Smith Entertainment Group

UTAH HPC PHASE 3

Utility Plan

C-300

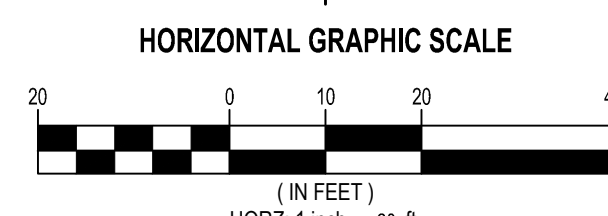
Find out if there is a conflict. Water Cannot be below Sewer per State code. It looks like the sewer is pretty deep. Water is about 4 to 5 feet.

Need a stormdrain notes.

FYI, I'm going to waive the PCMA until phase 4.
